1. PURPOSE AND SCOPE OF THIS MEMORANDUM

The subject property is the Pembroke Recreation Center at 128 Center Street.

North Entrance (original building) (2 spaces)

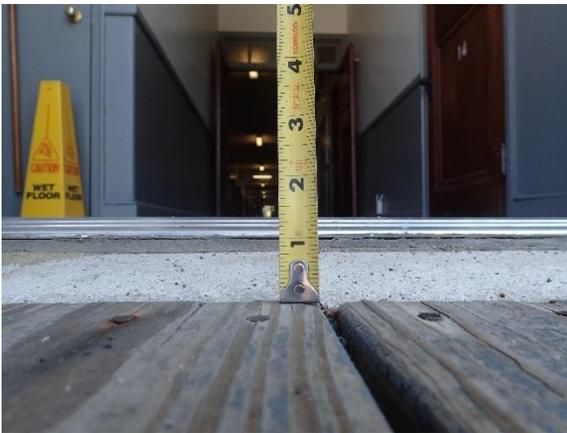
The front-to-back and cross-slope of the spaces exceeds the ADA standard of 1:48 (1.2 degrees). The route to the access ramp also exceeds the allowable slope and crosses asphalt pavement in very poor condition. There is no designated access aisle and the lower space is overlapped by a portion of the adjacent ramp.

A switchback wood access ramp leads to the building entrance. This ramp is generally in

conformance with ADA standards for dimension, slope and railings, but has the following deficiencies:

- gaps between planks exceed ½”
- Top landing approximately 1-1/2” below the building floor
- Deteriorated, irregular concrete at lower section with excessive “step” to wood portion of ramp.

i. Regrade and resurface accessible parking at North entrance, in conjunction with corrections to the access ramp and landing. Provide ADA-standard parking spaces and access aisle(s).

In conjunction with accessible parking corrections noted above, reconstruct or replace entrance ramp to provide top landing within ½” of the building floor and to eliminate excessive gaps between planks. Verify that one door leaf is 36” wide; replace doors with “unbalanced” set as necessary. Consider adding a power door operator for consistency with other Town buildings.

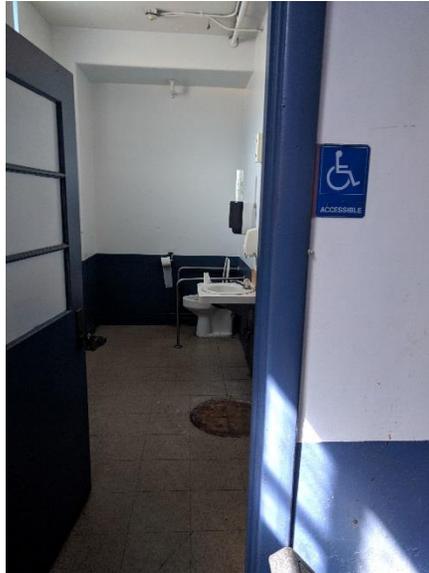
- i. Overall, no ADA-compliant restroom facilities are present at the Recreation Center. There are numerous toilet rooms in varying conditions of disrepair. In some instances efforts have been made to provide some degree of accessibility, but full accommodation is not available.

- ii. There is one toilet room designated as accessible. While the room itself is large enough to allow full compliance, the following elements do not meet ADA

standards:

- Door Hardware
- Grab Bars
- Rear wall clearance at toilet
- Lavatory handles
- Lack of closure panel or insulation at water piping under lavatory
- Placement of paper towel dispenser
